# Technical Service Information

## FORD 4R70E/4R75E CHANGES FOR 2004

**CHANGE:** Beginning at the start of production for 2004, Ford Motor Company introduced a new rear drive transmission with the designation 4R70E or 4R75E, which is based on the 4R70W. This transmission now has a redesigned Pump and Stator assembly, Intermediate Clutch assembly, Forward Drum, Sun Gear Shell, Center Support, Anti-Rattle Clip, an added Turbine Speed Sensor, a redesigned transmission case, a shorter Output Speed Sensor and a redesigned Ring gear.

Figure 1

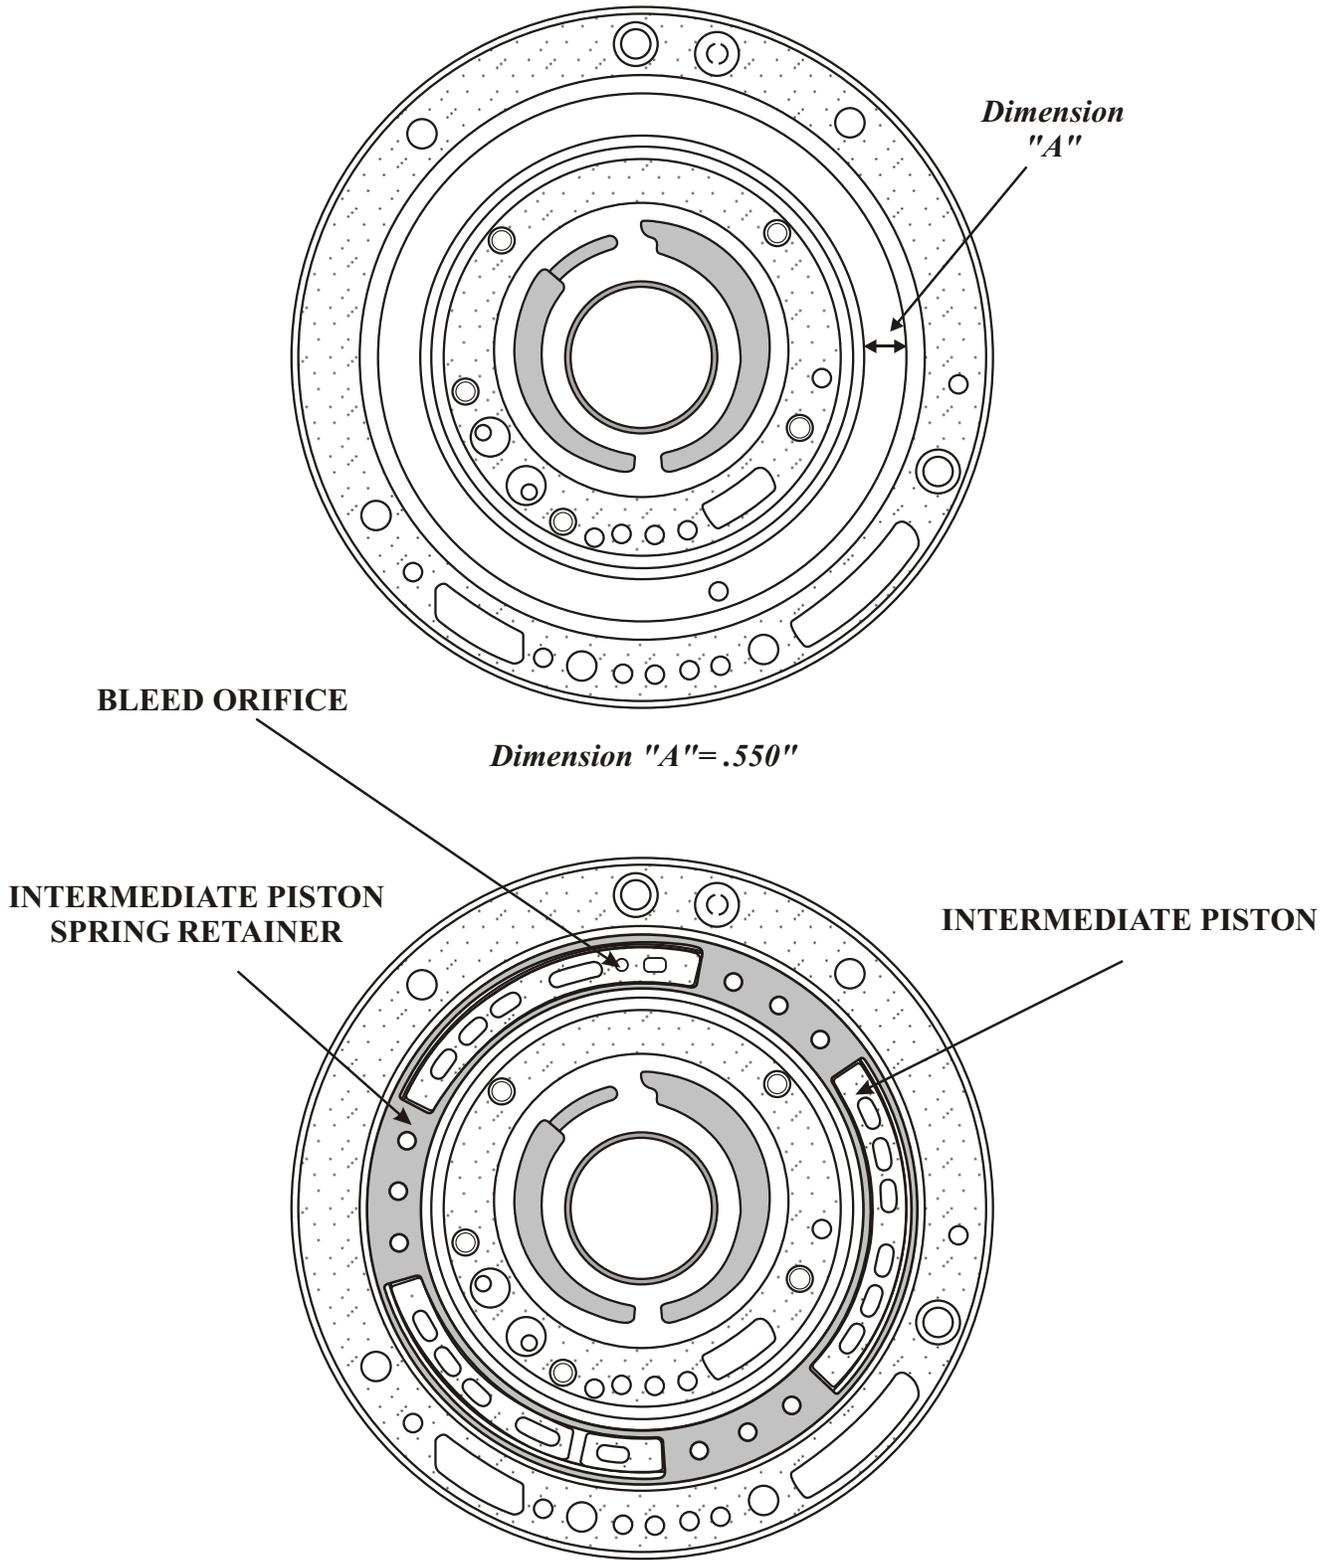
- (1) INTERMEDIATE CLUTCH PISTON AND PUMP BODY - The Intermediate Clutch Piston was changed from the previous design Aluminum piston with individual lip seals, as shown in Figure 1, to a stamped steel bonded rubber piston as shown in Figure 2. Along with this change, the Pump Body was redesigned to accommodate the new larger piston and the elimination of the Spring Retainer. A new return spring and retainer was added into the case as shown in Figures 3 and 4.

Figure 5

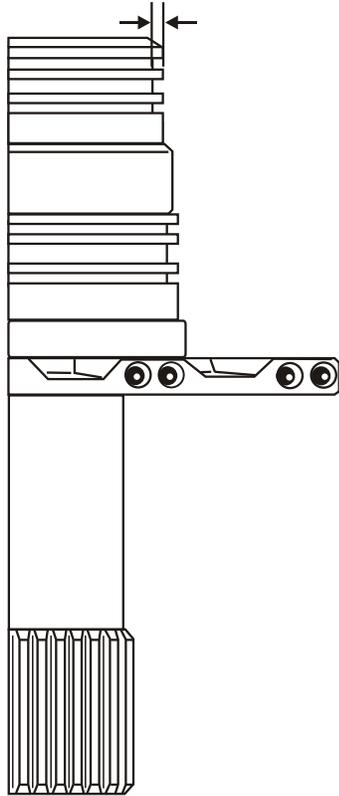
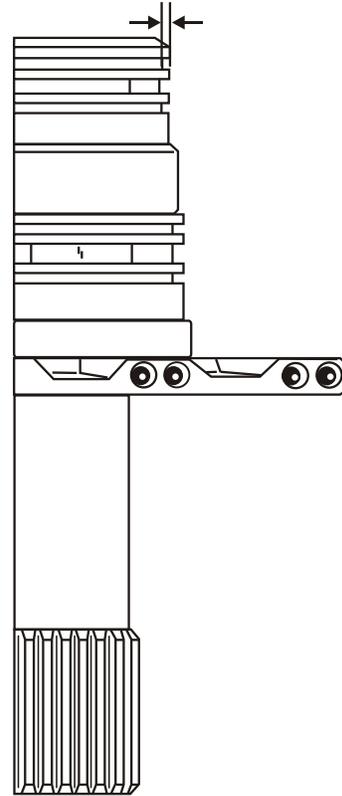
- (2) PUMP STATOR - The Pump Stator Forward Clutch sealing ring groove depth changed to accommodate a new Plastic Butt Cut Sealing Ring as shown in Figure 5.

**RING GROOVE  
DEPTH .100"**

**SEALING RING  
WIDTH .110"**

**RING GROOVE  
DEPTH .072"**

**SEALING RING  
WIDTH .083"**

**BUTT CUT PLASTIC  
SEALING RINGS**

**FORWARD CLUTCH DRUM**

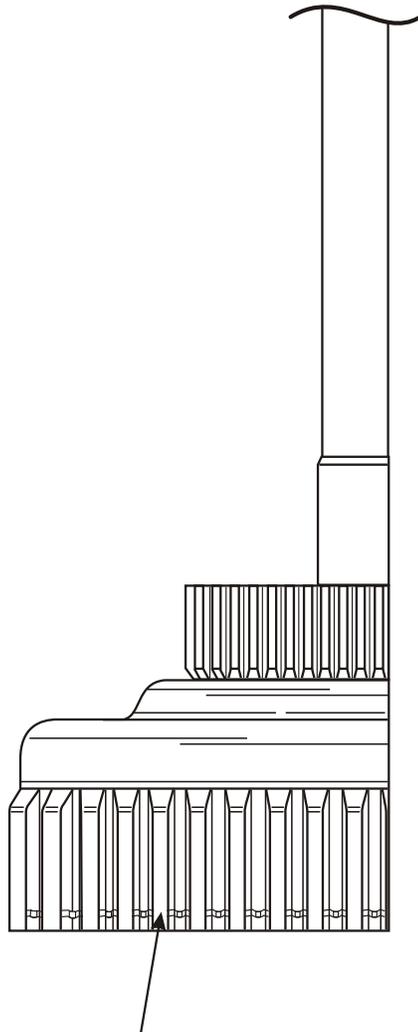
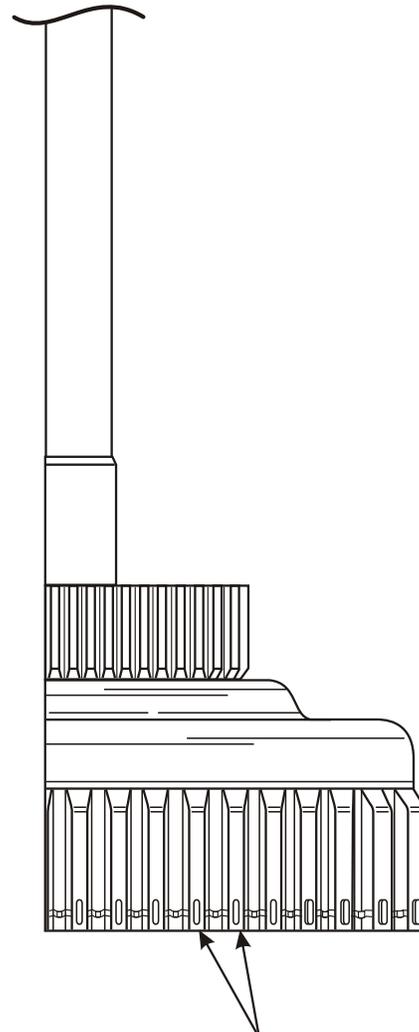
- (3) FORWARD DRUM - The Forward Drum had a stamping change to provide projections for the added Turbine Shaft Speed Sensor, as shown in Figure 6.
- (4) SUN SHELL - The Sun shell can be easily identified by the new rivets that retain the shell to the Sun Gear as shown in Figure 7. The new shell is manufactured from a non-ferrous metal which will not attract a magnet, so the added turbine sensor can read the Forward Clutch Drum. **NOTE: 2005 models do not have the rivets for identification and will retrofit to 2004 models.**

*NO PROJECTIONS*

*34 STAMPED PROJECTIONS  
ON THE OUTSIDE OF THE DRUM  
THAT THE ADDED TURBINE SENSOR  
READS FROM*

Figure 7

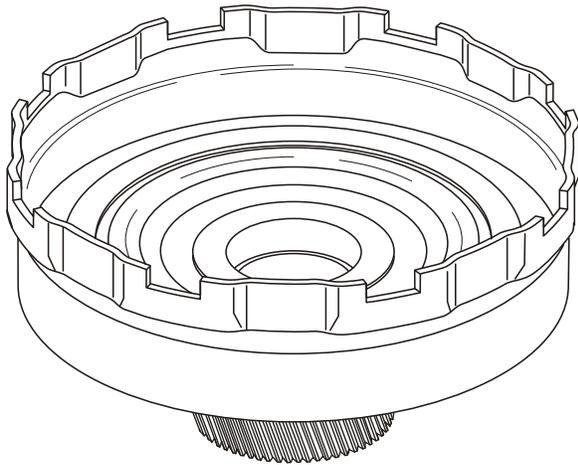
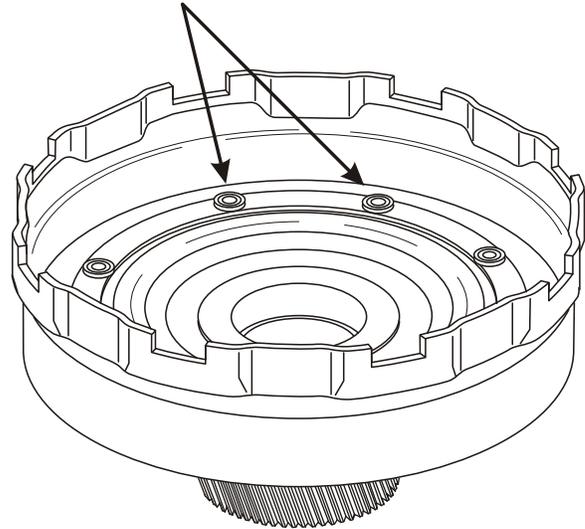
***New Sun Shell Is Now Riveted  
To The Sun Gear And Hub***

***NOTE: The New Sun Shell is made from  
a non-ferrous material so the Turbine sensor  
can read the Forward drum.  
In the 2005 model year the same type of Sun Shell  
is used and the rivets for identification are removed***

Figure 8

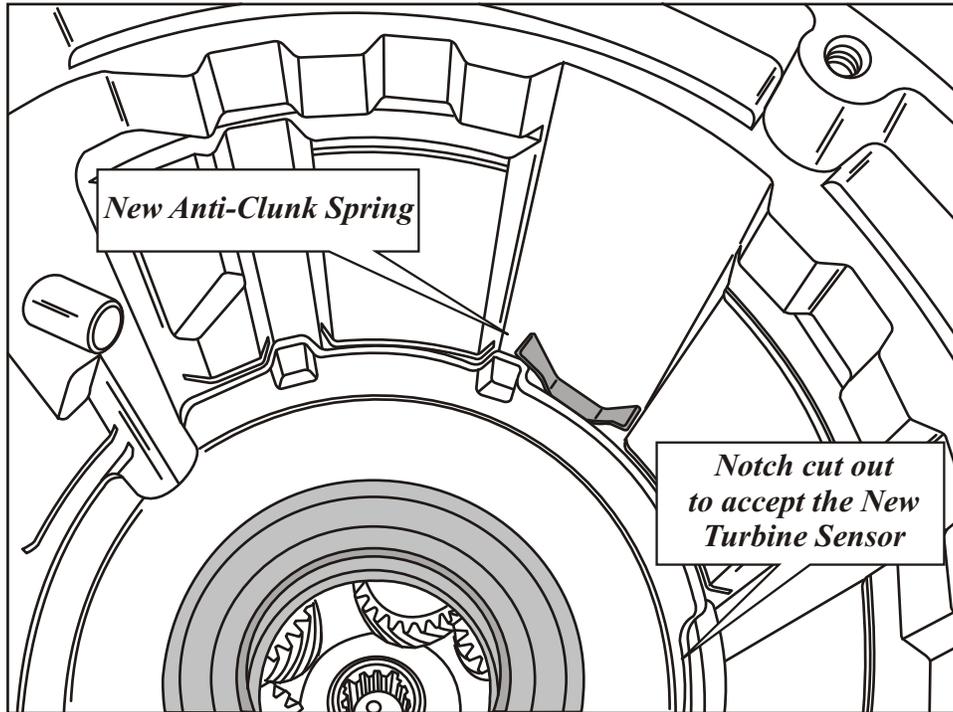
- (5) CENTER SUPPORT - The new design Center Support has a notch cut out of it to accommodate the added Turbine Sensor, as shown in Figure 8. A new design Anti-rattle Clip was also added for ease of assembly, which was changed in the 2002 model year.

**NOTE:** *The anti-clunk spring was changed in the 2002 model year.  
Ford part number 2L3Z-7F277-AA*

Figure 9

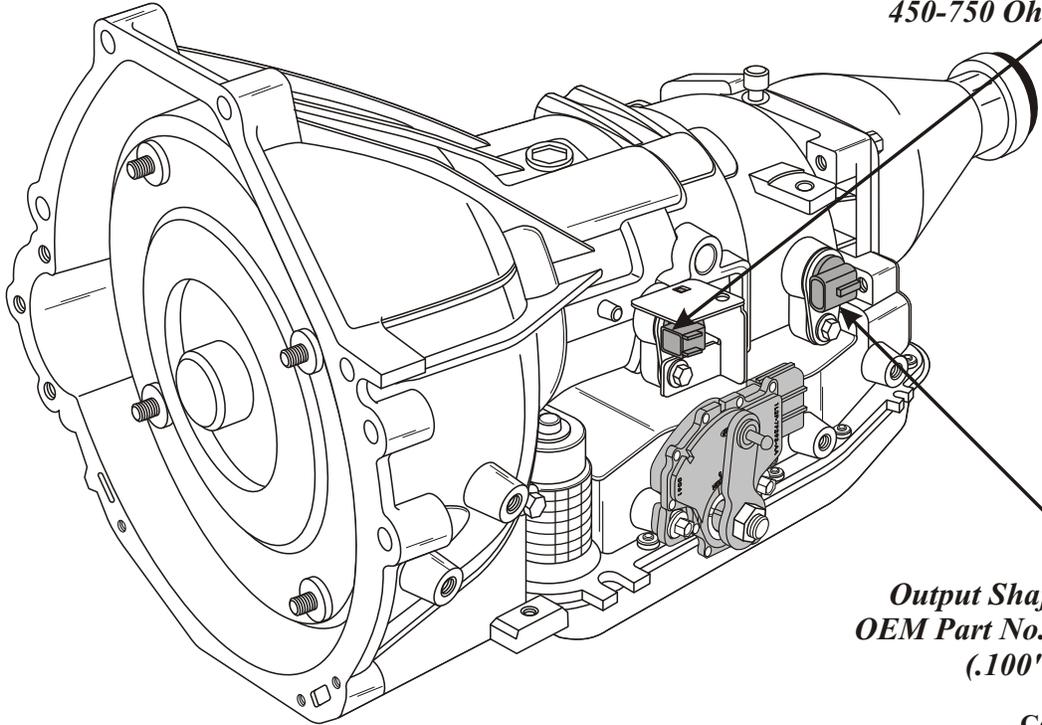
- (6) TRANSMISSION MAIN CASE - The case was changed to accommodate the added turbine sensor as shown in Figure 9.
- (7) REAR INTERNAL RING GEAR - Now manufactured with extended parking lugs on the ring gear to trigger the New **Shorter** Output Speed Sensor, instead of the previous design holes in the center of the ring gear as shown in Figure 10.

*"Added" Turbine Shaft Speed Sensor  
OEM Part No. 3L3Z-7M101-AA  
450-750 Ohms Resistance*

*Output Shaft Speed Sensor  
OEM Part No. 3L3Z-7H103-AA  
(.100" Shorter)*

Figure 10

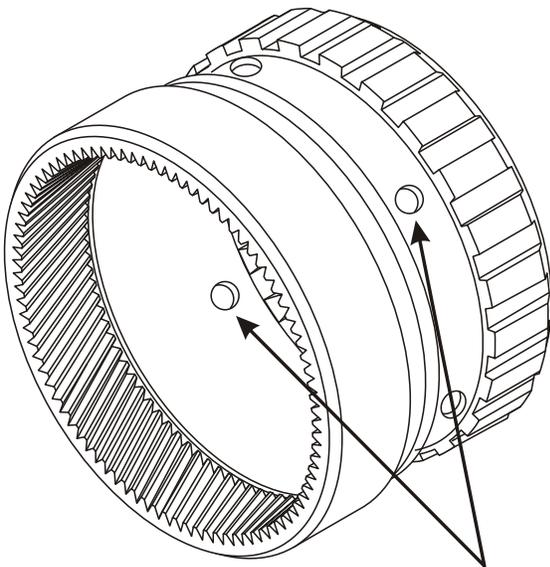
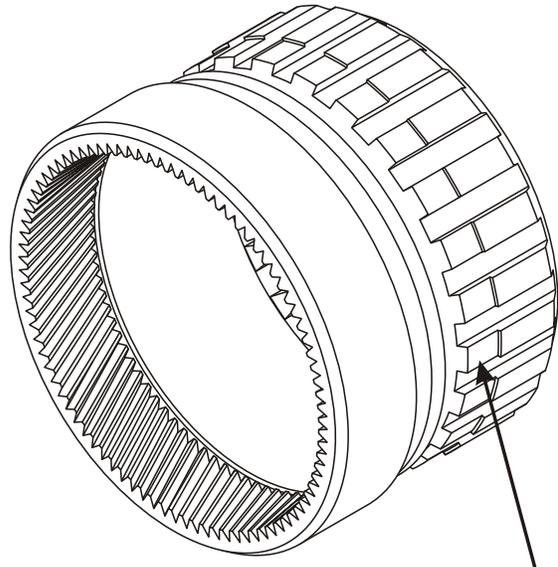
*Holes To Trigger  
Speed Sensor*

*Extended Teeth To Trigger  
Speed Sensor*
